## **II. Amendments to the Drawings**

### III. Remarks

Independent Claim 1, from which Claims 2 and 7-11 depend, is directed toward a header for a heat exchanger that has a substantially planar base portion and a pair of step portions that extend laterally at an angle between about 15 and 75 degrees as a straight segment from the plane of the base portion. The header of Claim 1 has a plurality of substantially parallel slots spaced apart along the length of the header, with each slot extending across the width of the base portion and into the step portions. Each slot is engaged with a single tube such that the header structurally supports the respective tube. Furthermore, Claim 1 is currently amended to state that the header serves as a manifold connecting in fluid communication an end of a tube to an end of at least one other tube.

Fig. 3C

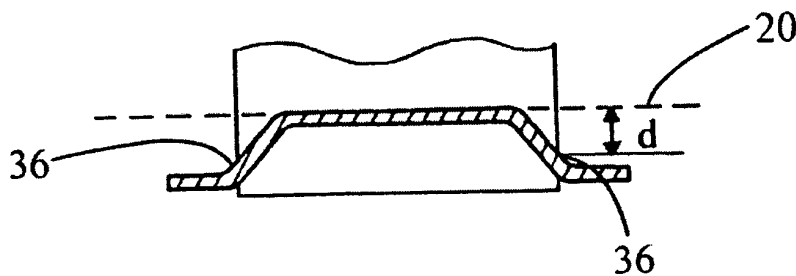
Examiner has stated that the specification as originally filed lacks an adequate written description of the invention. Examiner has further stated that "[t]here is no basis for the recitation 'an angle between about 15 and 75 degrees' in set forth in claim 1." Applicant respectfully traverses this rejection.

Applicant respectfully directs Examiner's attention to Figure 3C of the original specification, which is duplicated below for convenience of discussion, as well as paragraphs [0025] and [0026] of the specification as originally filed.

Figure 3C shows a separation distance (d) between the terminal ends 62 of the end sections 58 and the plane of the planar portion 56 (See Figure 5 and paragraph [0025]). Paragraph [0025] states, in the second-to-last sentence, that the separation distance (d) may be in the range from about 2 mm to about 20 mm. Paragraph [0026] states that the end sections 58 are about 2.5 mm to 28 mm long. As shown above, part of the dashed line showing the line of deformation 20 can be combined with the distance (d) and the end section 58 of the slot 52 to form a right triangle. Claim 1 states that each step portion extends laterally at an angle between about 15 and 75 degrees from the plane of the base portion. This angle is the angle opposite distance (d) in Figure 3C (shown above). The sine of an angle is equal to the length of the opposite side divided by the length of the hypotenuse. Therefore, the sine of the angle of Claim 1 [hereinafter  $\alpha$ ] is the distance (d) divided by the length of the end section 58:

$$\sin \alpha = \frac{(d)}{\text{length}_{\text{end-section}}}$$

The originally filed specification gives dimension ranges for (d) and dimension ranges for the length of the end section 58, which can be substituted into the above equation:

$$\sin \alpha = \frac{2 - 20\text{mm}}{2.5 - 28\text{mm}}$$

Solving for the above equation, the range of the angle  $\alpha$  is about 4.1 degrees to about 89.9 degrees. Therefore, the range of the angle of Claim 1 (15 to 75 degrees) is well within the range that a person having ordinary skill in the art would be taught from the specification as originally filed.

Since the angle range claimed in the previously amended Claim 1 merely recites an inherent feature of the original specification, Applicant respectfully submits that there is support for Claim 1 in the specification as originally filed.
